TELEDYNE CONTINENTAL[®] AIRCRAFT ENGINE

SERVICE BULLETIN

SB01-5

SUBJECT: STARTER ADAPTER BEVEL GEAR INSPECTION

FIGURE 1
Exploded View P/N 646220A38 Starter Adapter

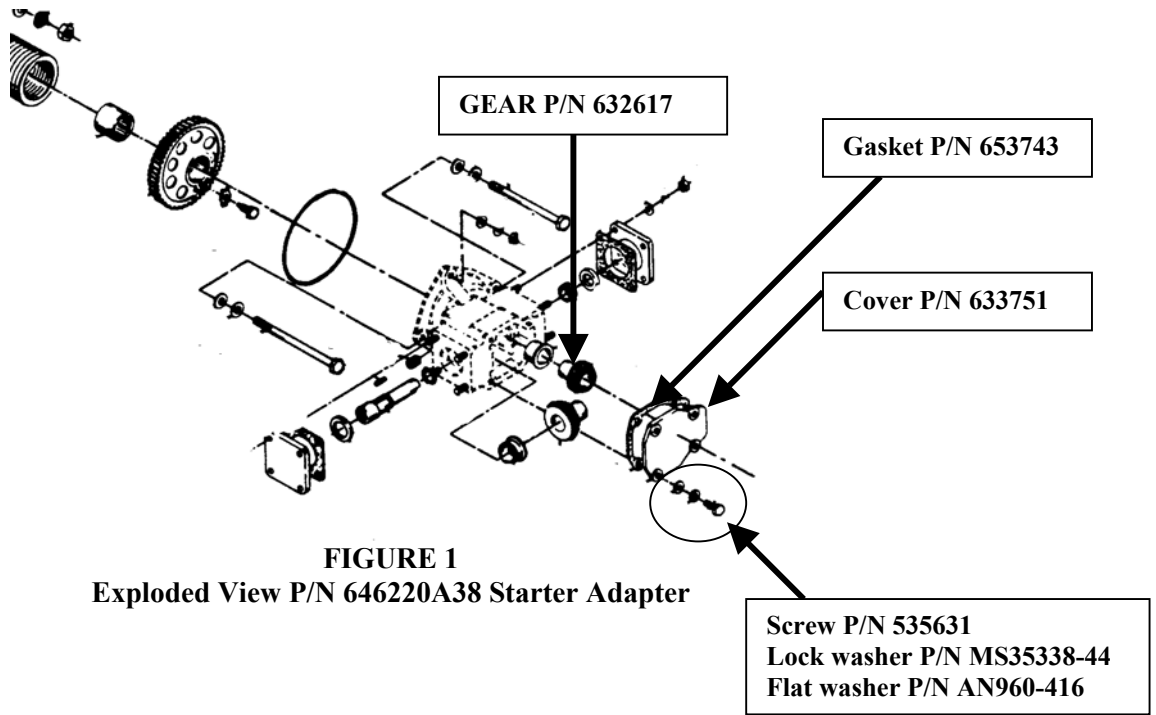
1. In accordance with the aircraft manufacturer's instruction gain access to the engine and specifically the engine accessory area.
2. Referring to Figure 1, remove the "T" drive cover plate P/N 633751, by removing 4 each screws, 4 each lock washers and 4 each flat washers. Remove gasket P/N 653743.
3. Visually inspect bevel gear P/N 632617 for indication of gear tooth distress, spalling, broken or chipped gear teeth. Inspect interior of "T" drive housing for gear debris.
4. If visual inspection DOES NOT reveal any damage to bevel gear P/N 632617 and there is no gear debris noted in "T" drive housing interior reinstall cover P/N 633751 using a new gasket P/N 653743 and new lock washers P/N MS35338-44. Torque screws P/N 535631 to 75 to 85 inch pounds.
On completion of the above inspection, complete the owner notification form and mail it or fax it to TCM. ①

5. If visual inspection reveals damage to bevel gear P/N 632617 or if there is debris in the interior of the "T" drive housing the starter adapter assembly will have to be removed for repair or replacement. Contact TCM Technical Service Support at 1-888-826-5465

FIGURE 2
Exploded View P/N 646220A54 Starter Adapter

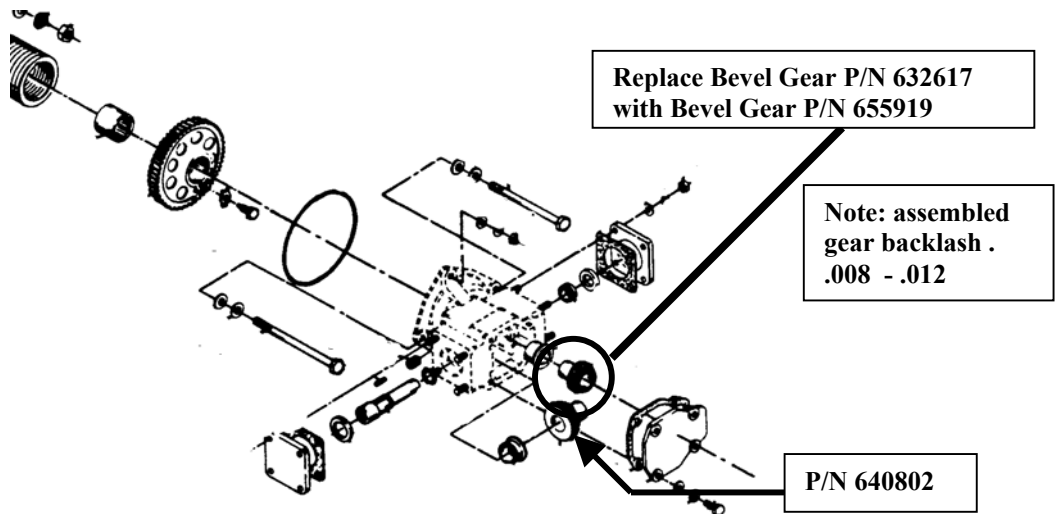
Starter adapters P/N 646220A38 will be replaced with starter adapter P/N 646220A54 when they become available. Service spare bevel gear P/N 632617 will be replaced by bevel P/N 655919. During field repair of overhaul bevel gear P/N 655919 must be used with gear P/N 640802. Refer to Figure 2.
